TO:  Director, Preliminary Plan Review Bureau  <b>SUPERSEDED BY EI 79-022</b> <b>EFFECTIVE 8/2/1979</b>	<h2 style="text-align: center;">ENGINEERING INSTRUCTION</h2> <p style="text-align: center;">NEW YORK STATE DEPARTMENT OF TRANSPORTATION</p> SUBJECT: <b>HIGHWAY BARRIER &amp; HIGHWAY RAILROAD BARRICADE</b> STANDARD SHEET 630-1R1 Subject Code: 7.27-2-630
Distribution: <input checked="" type="checkbox"/> Main Office <input checked="" type="checkbox"/> Regions <input type="checkbox"/> Special	Code: <u>EI 76-50</u> Date: <u>7/14/76</u>
APPROVED:  Deputy Chief Engineer (Facilities Design)	Supersedes: <b>EI 72-095 DATE 10/19/72</b>

STATE OF NEW YORK  
DEPARTMENT OF TRANSPORTATION  
DESIGN AND CONSTRUCTION  
DIVISION  
**HIGHWAY BARRIER**  
AND  
**HIGHWAY-RAILROAD BARRICADE**

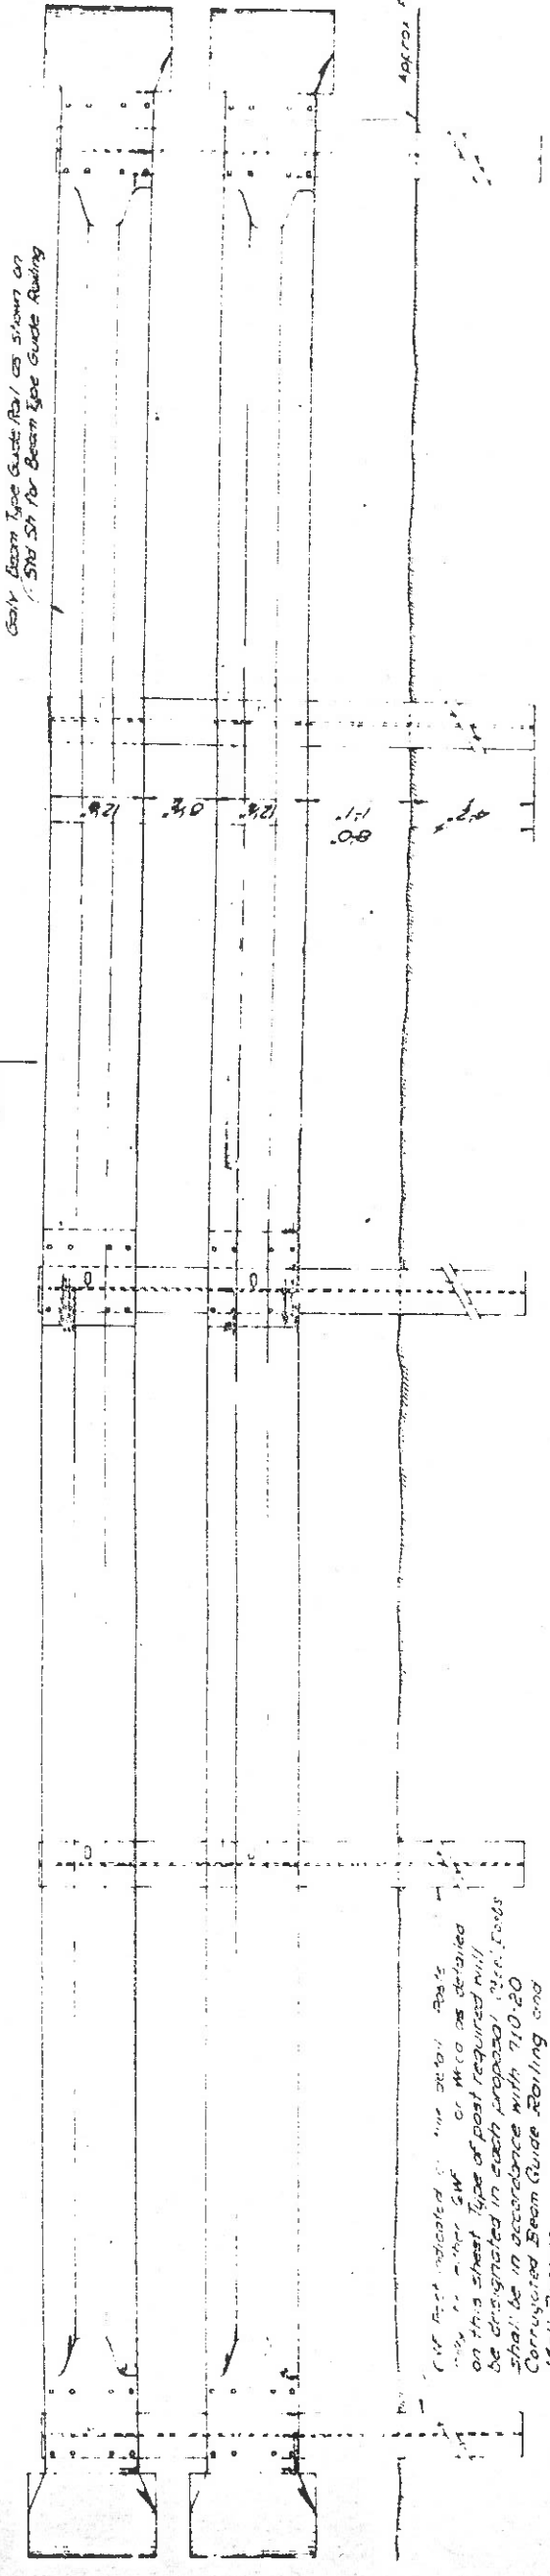
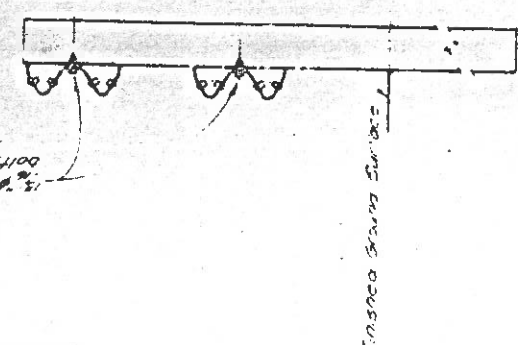
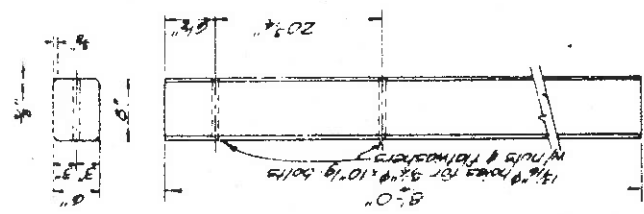
This revision adds alternate black and white reflective sheeting stripes to increase the visibility of the barrier. The Engineer when approving the method of installation of the stripes must keep in mind that this barrier is composed of two horizontal W sections supported by steel or wood posts and direct application of the stripes to the W section will produce an undesirable effect. One acceptable method of application would be to take the W 190 Clearance Marker shown in Sect 240.3 of the New York State Department of Transportation Manual of Uniform Traffic Control Devices, turn it on its side and bolt it to the upper and lower rail of the barrier. Any other method producing a flat surface for the stripes which is acceptable to the Engineer may be used.
